RESERVOIR REGULATION MANUAL
FOR
PAINTED ROCK RESERVOIR

SUBJECT: Reservoir Regulation Manual for Painted Rock Reservoir, Gila
River Basin, Arizona and New Mexico

ENGINEER (24 July 62) 2nd Ind
SUBJECT: Reservoir Regulation Manual for Painted Rock Reservoir, Gila River Basin, Arizona and New Mexico

The Reservoir Regulation Manual for Painted Rock Reservoir is approved subject to the following comments:

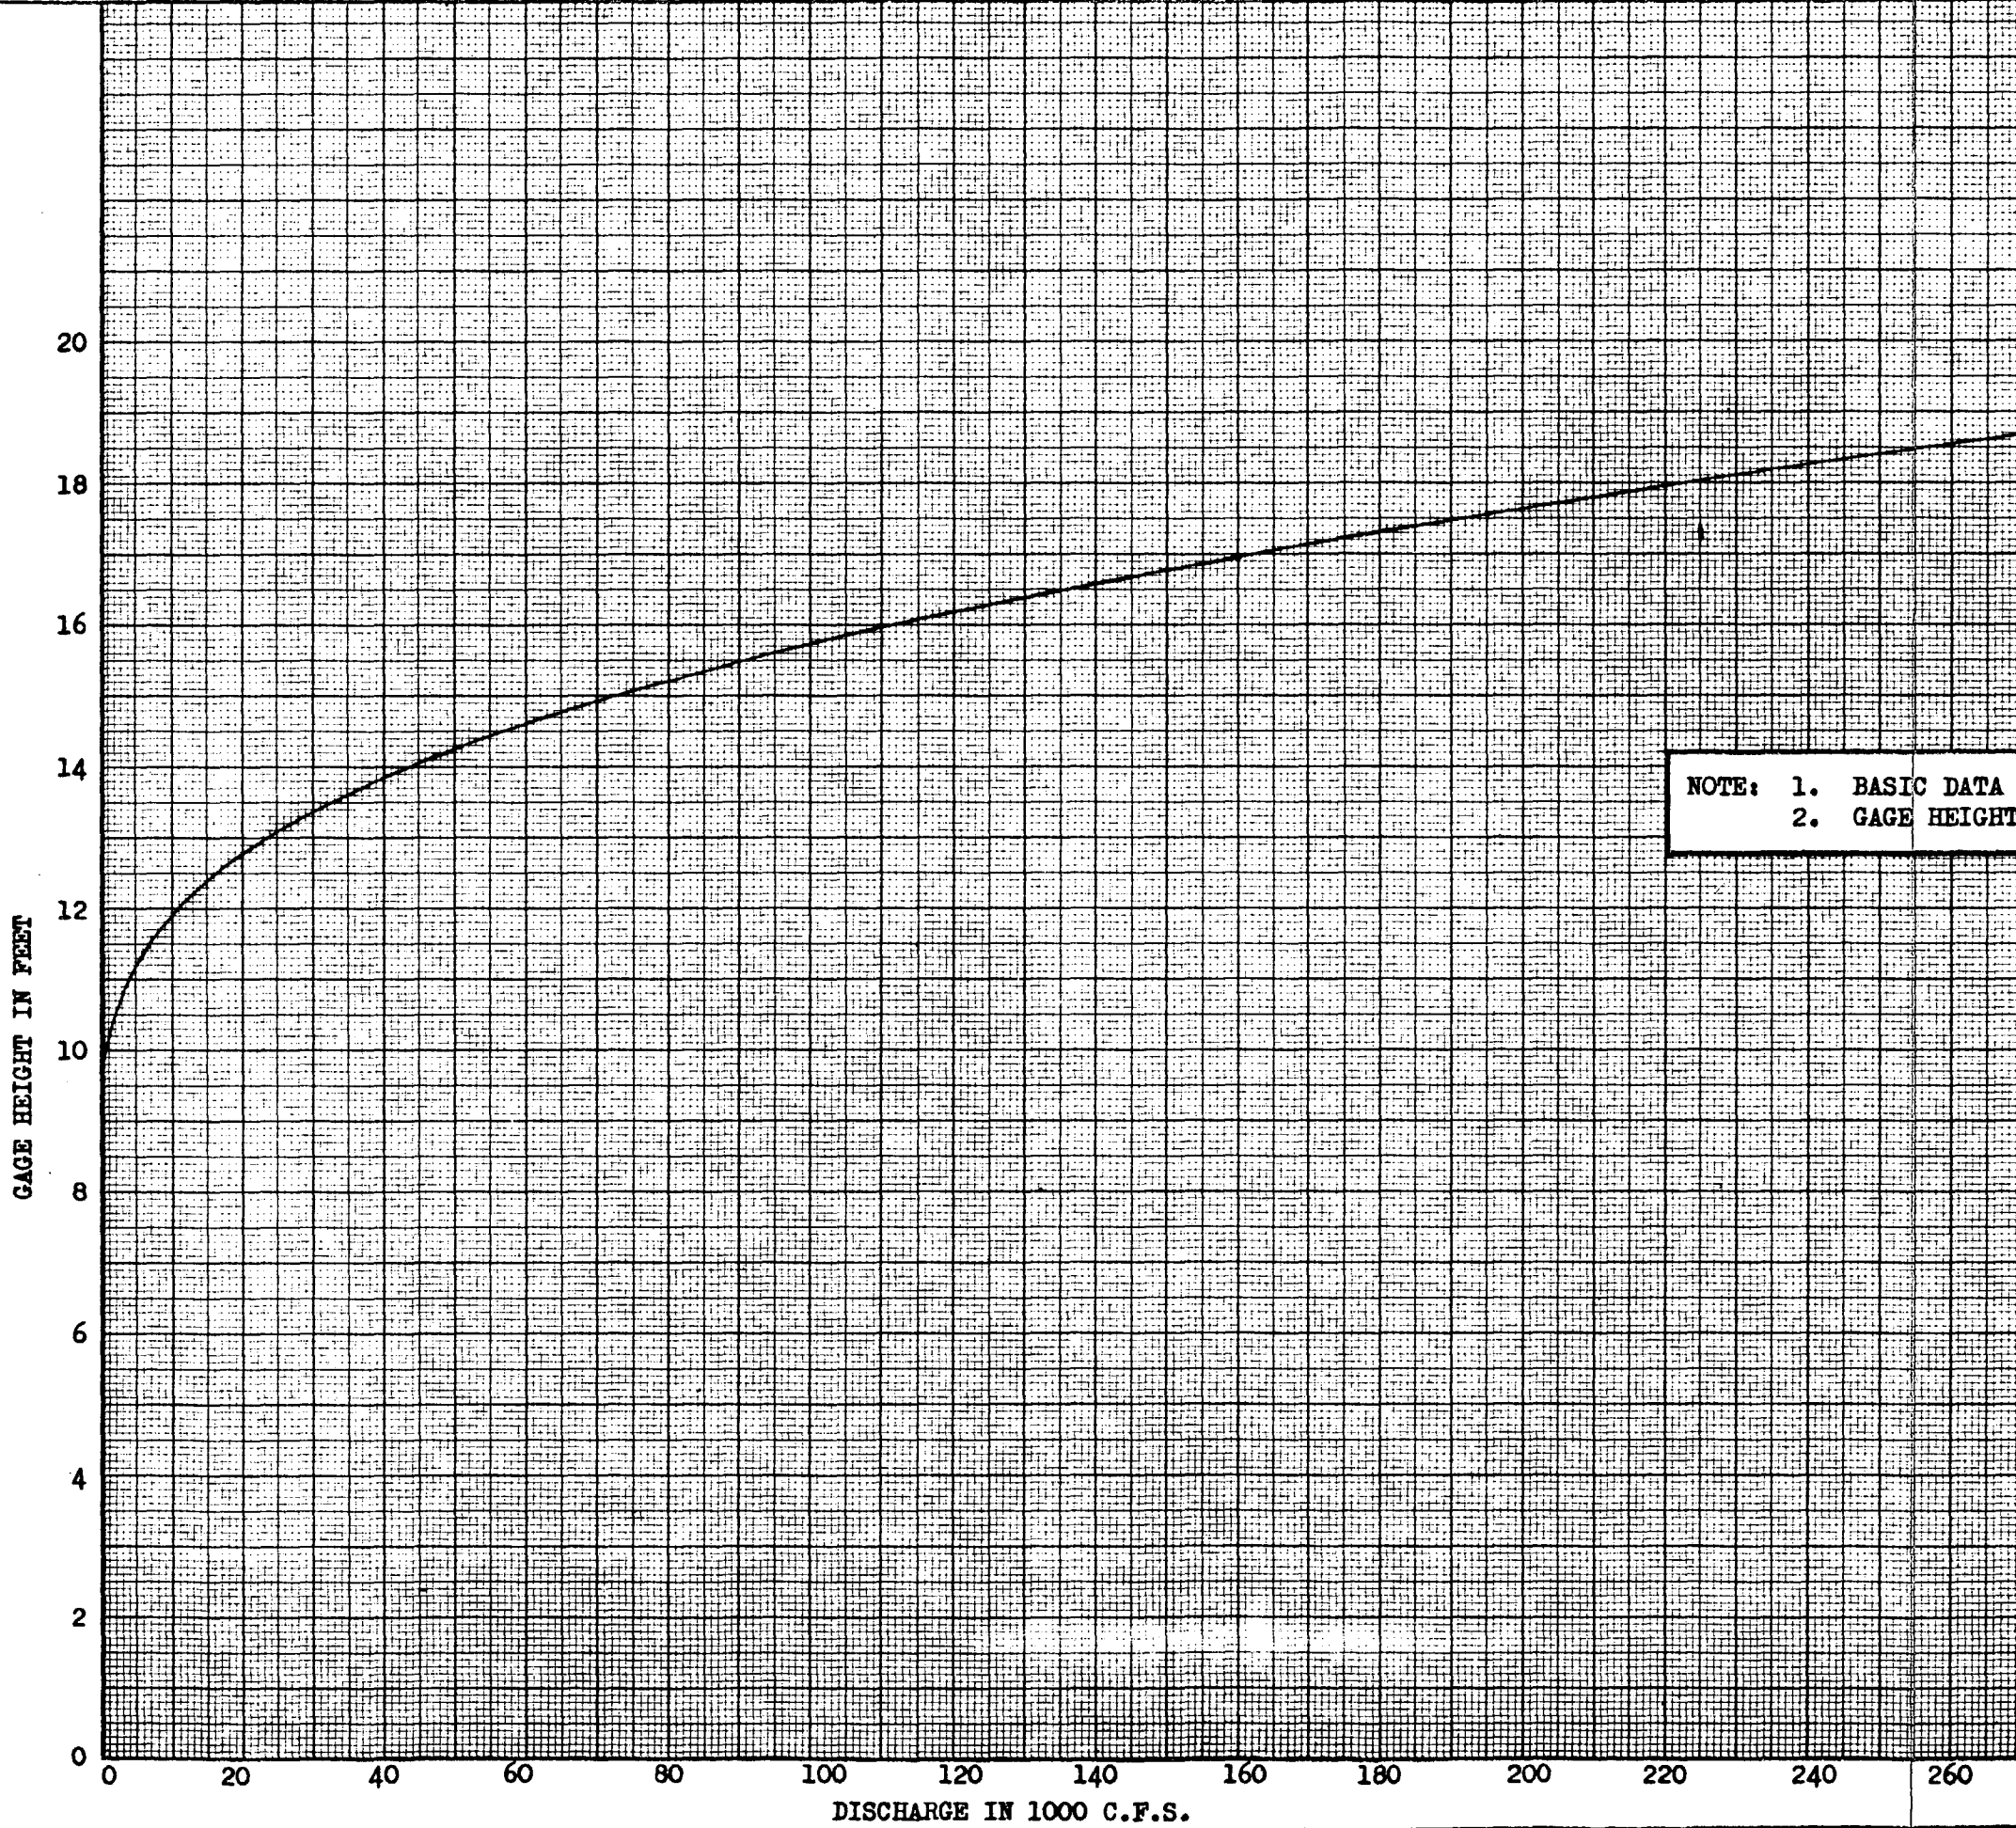
g. Rating curves for key stations have not been included. Possibly that is because they shift frequently; if so, that should be explained. Some information on stages during floods should be given, and adding stages to Table II would be helpful. If the reservoir is to be operated for Colorado River floods, similar data for the Colorado River should be given.

plates 20 through 23. The curves for the Dome, Cibola and Yuma stations are subject to change because of unstable streambeds. The curve for the Gillespie Dam station is reasonably firm.
